# DEVELOPMENT HEARING OFFICER

**PR-2021-009917**

THE GROUP | RON HENSLEY agent for MJ HOSPITALITY LLC requests the aforementioned action(s) for all or a portion of: TRACT L-1-B-1-A and LT 21-A, ATRISCO BUSINESS PARK zoned NR-BP, located at 531 SILVER CREEK RD NW between SILVER CREEK and UNSER containing approximately 4.05 acre(s). (K-10)

REPLAT OF 2 EXISTING LOTS

# DEVELOPMENT SKETCHES ATRISCO BUSINESS PARK

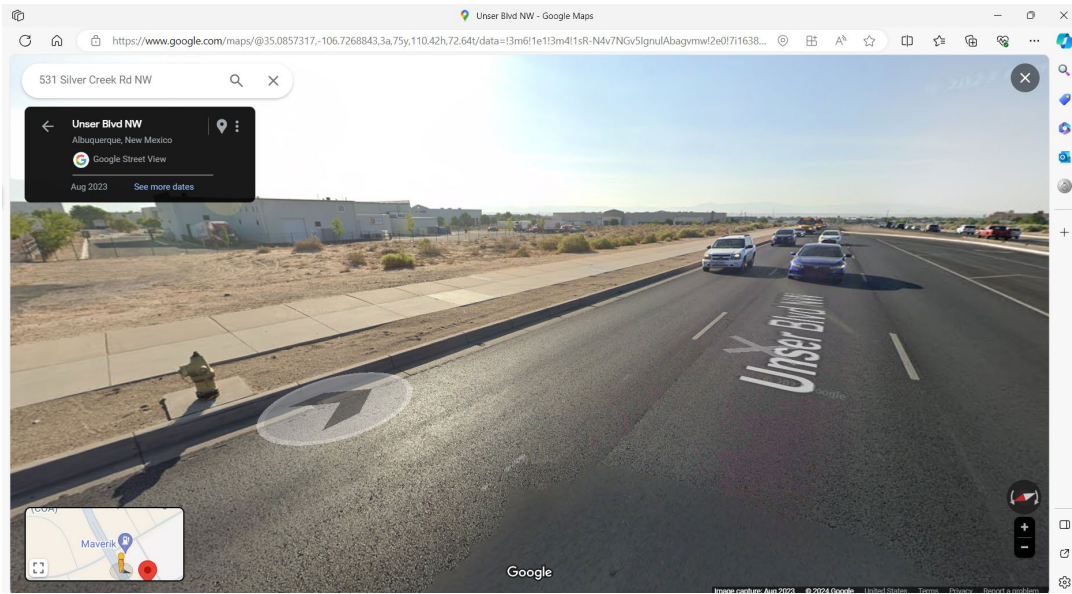
- Please note that per the Atrisco Business Park Master Development Plan, properties adjacent to Unser Boulevard shall have a 6-foot wide sidewalk with a minimum 12-feet between the back of curb and the sidewalk. An analysis of the site in Google Street View (see picture below) appears to depict a sidewalk at least 6-feet in width, but the landscape buffer doesn't appear to be a minimum of 12-feet in width between the back of curb and the sidewalk as required by the Atrisco Business Park Master Development Plan.

Properties adjacent to Unser Boulevard shall have a 6 foot wide sidewalk with a minimum landscaped area of 12 feet between the back of curb and the sidewalk. All other collector and major local streets within the site shall have 4 foot wide sidewalks. It is recommended that the sidewalk
